SERVICE BULLETIN REVISION NOTICE

NACELLE – HYDRAULIC SYSTEM – REPLACEMENT OF UNION ON THE ENGINE DRIVEN PUMP (EDP) SUCTION LINE OUTLET

Turbojet Engine Service Bulletin No. V2500-NAC-29-0266 Revision No. 1 dated March 23, 2020

NACELLE – HYDRAULIC SYSTEM – REPLACEMENT OF UNION ON THE ENGINE
DRIVEN PUMP (EDP) SUCTION LINE OUTLET

**REPLACEMENT OF EDP UNION
FIGURE 1**

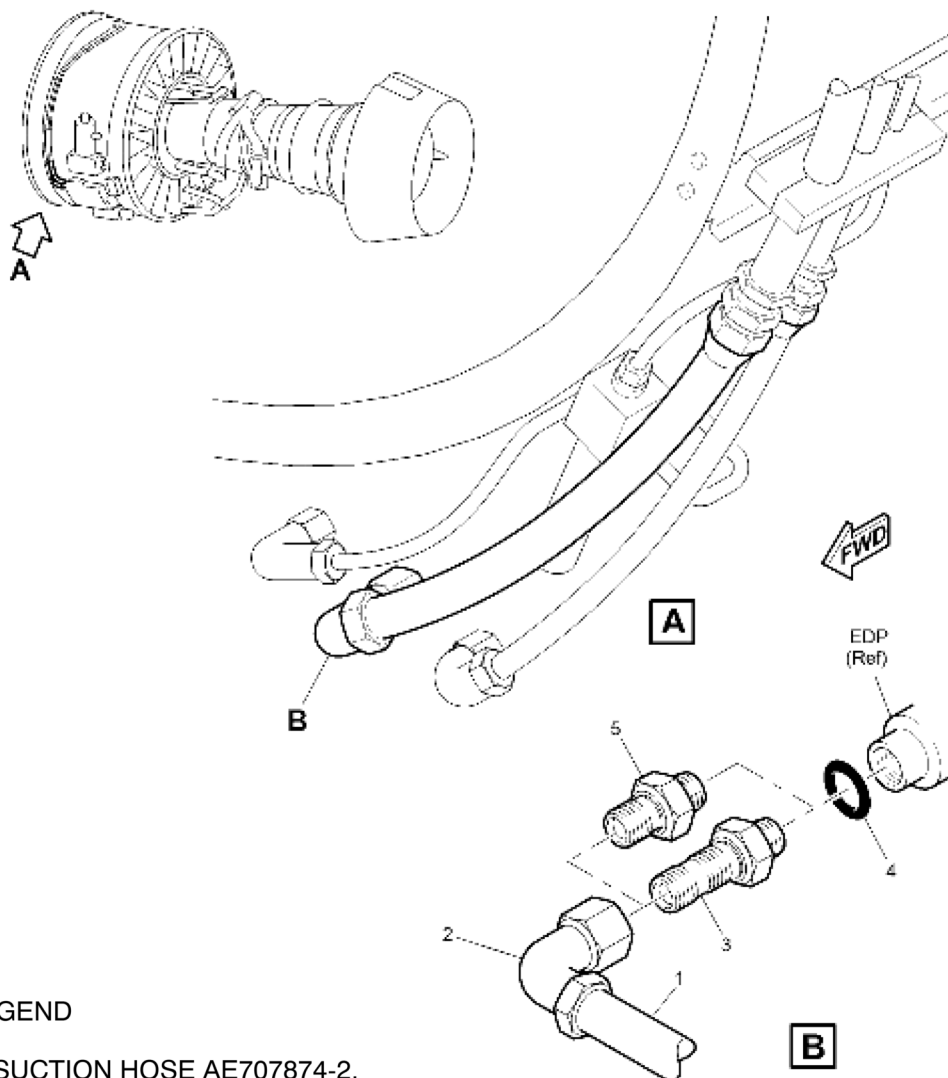
1. Condition: Clearance between the union on the EDP suction line outlet and adjacent hydraulic parts may be close to the minimum if the dampener is installed to Eaton EDPs (as per VSB V2500-NAC-29-0265 or MOD 159213).

This Service Bulletin is to inform operators that have Eaton EDPs fitted and with VSB V2500-NAC-29-0265 or MOD 159213 (installation of dampener) embodied that the current union on the EDP suction line outlet should be replaced with the new union to improve clearances.

A. Removal of the union (3) from the EDP (ref). Refer to Figure 1.

- (1) Put a suitable container below the coupling (2) / union (3) connection to the EDP.
- (2) Hold the union (3) with an applicable wrench and disconnect the coupling (2) from the union.
- (3) Let the hydraulic fluid flow into the container.
- (4) With an applicable wrench, remove the union (3) and packing (4) from the EDP (ref).
- (5) Discard the packing (4).
- (6) Put a suitable protective cover on the end of the coupling (2) and the EDP (ref).

To restore the Union (5) torque specified in the Accomplishment Instructions to the Hydraulic System production drawing specification of 900 - 1000 lbf-in. (101.7 - 113.0 N.m).

B. Installation of the new union (5) on the EDP (ref).

- (1) Remove the covers from the new union (5), the coupling (2) and the EDP (ref).
- (2) Lightly lubricate the threads and abutment faces of the union (5) and the coupling (2) with the hydraulic fluid used in the aircraft hydraulic system.
- (3) Lubricate the new packing (4) with the hydraulic fluid used in the aircraft hydraulic system (ref SPM Task 70-44-01-400-501) and install the union (5) and packings (4) to the EDP.
- (4) Torque the union (5) to 900 – 1000 lbf-in. (101.7 – 113.0 N.m).
- (5) Connect the coupling (2) to the union (5).
- (6) Hold the union (5) with an applicable wrench and with a second wrench, torque the connector nut of the coupling (2) to 800 – 900 lbf in. (90.4 – 101.7 Nm).
